Illinois Department of Transportation
 PASSED January 1, 2017
 ENGINEER OF POLICY AND PROCEDURES
 APPROVED *Michael Brown* January 1, 2017
Marcus M. Skiles
 ENGINEER OF DESIGN AND ENVIRONMENT
 ISSUED 1-1-2003

TRAFFIC BARRIER TERMINAL, TYPE 6B
 STANDARD 631033-07
 (Sheet 1 of 2)

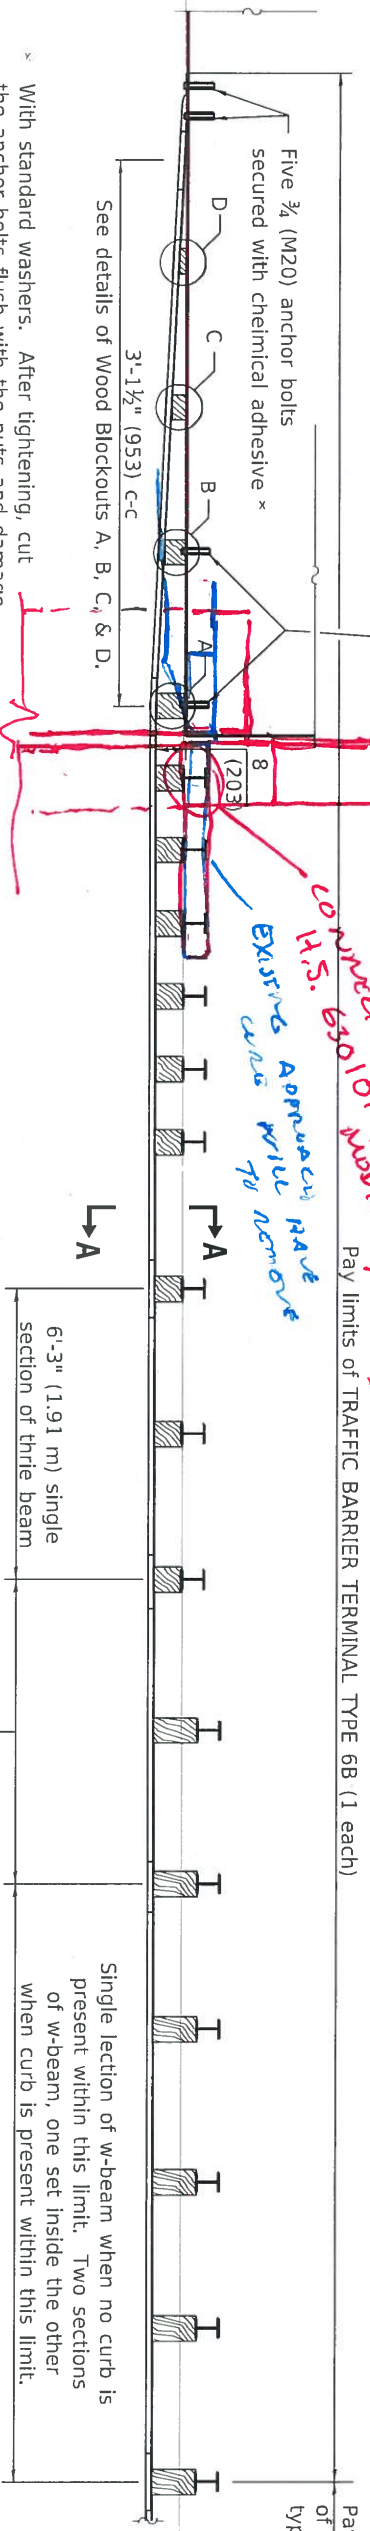
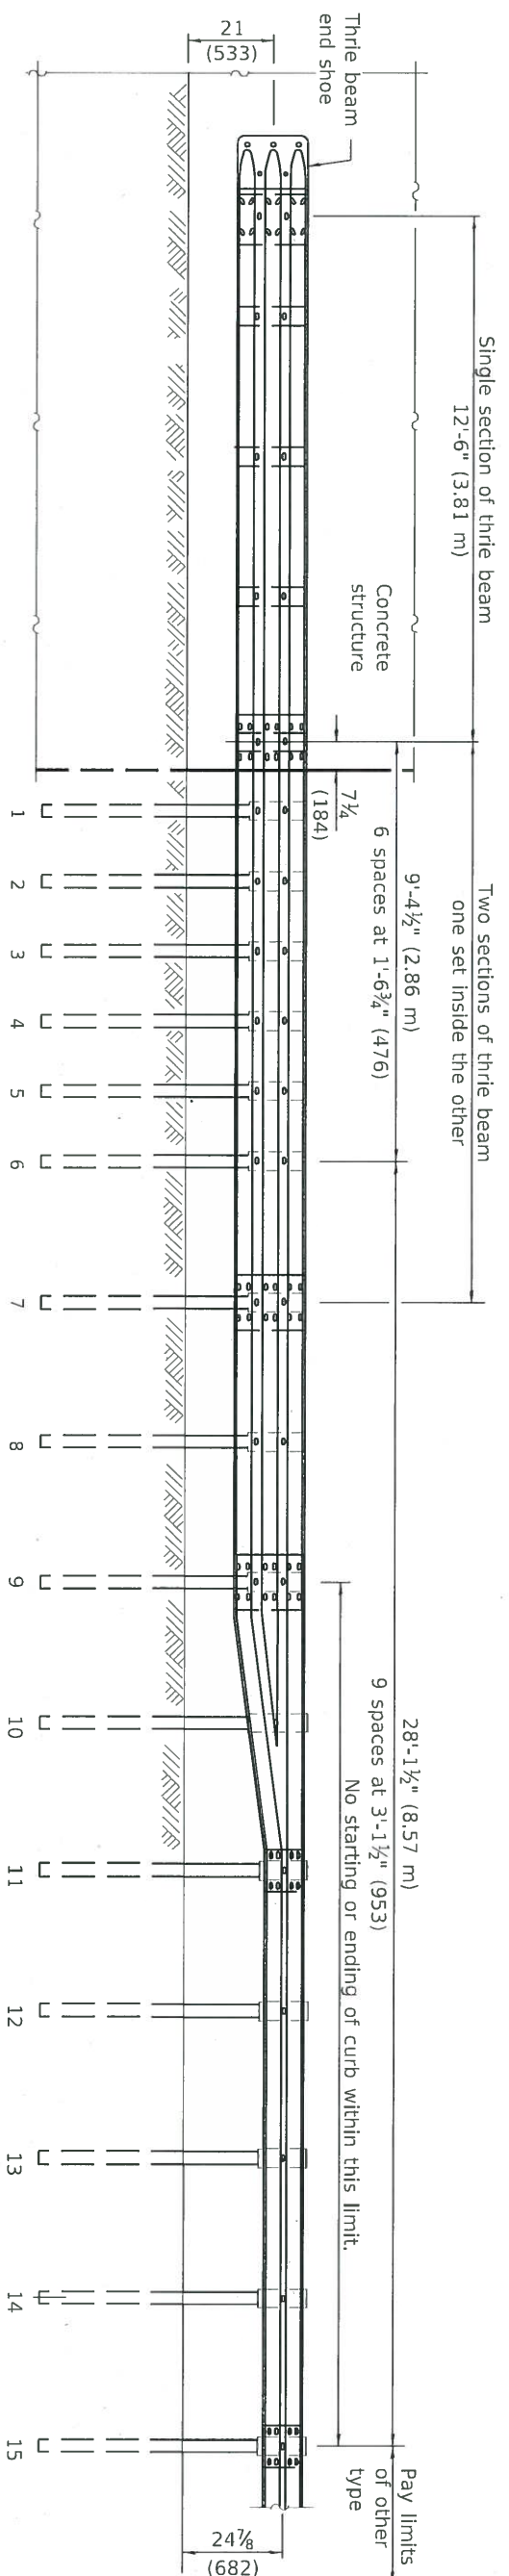
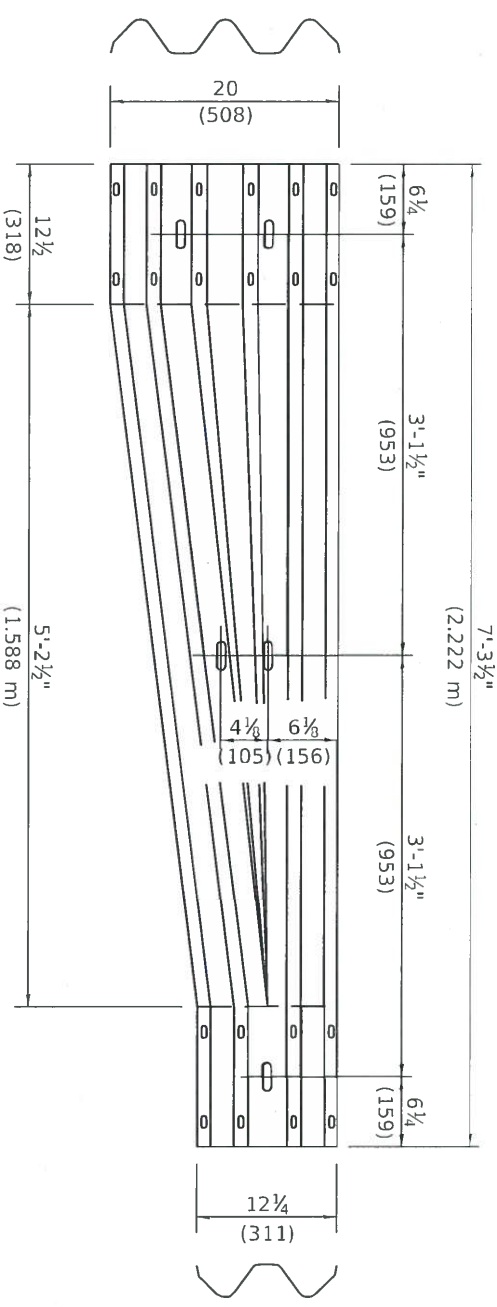
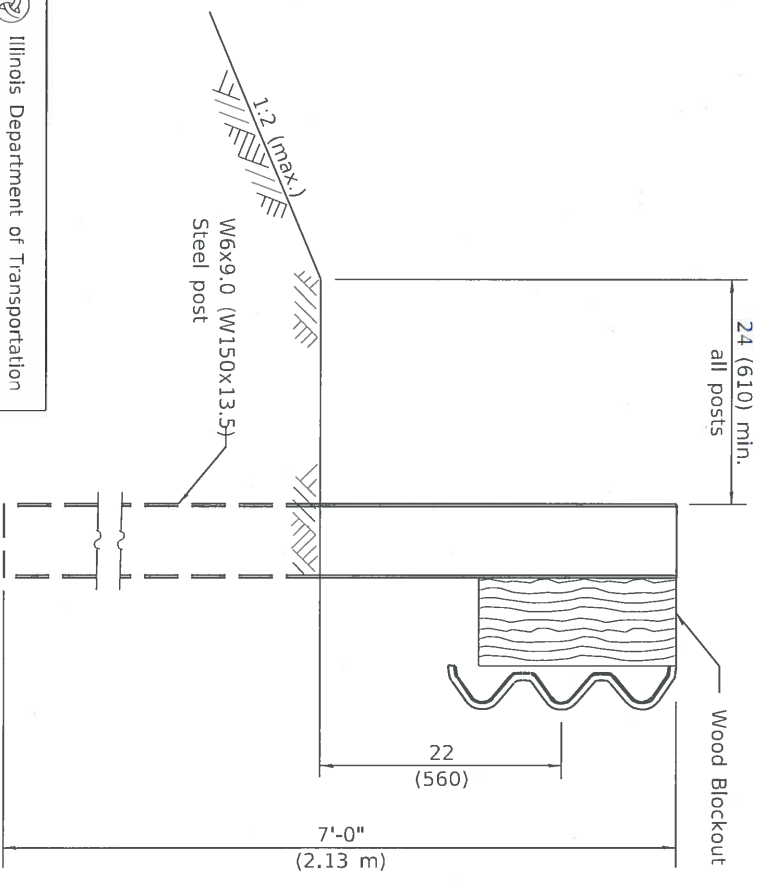
CONNECT TO 630101 MODIFICATION = DESIGN. ABOUT 15% WITH TO -80% PER. EXISTING CURB WILL REMOVE
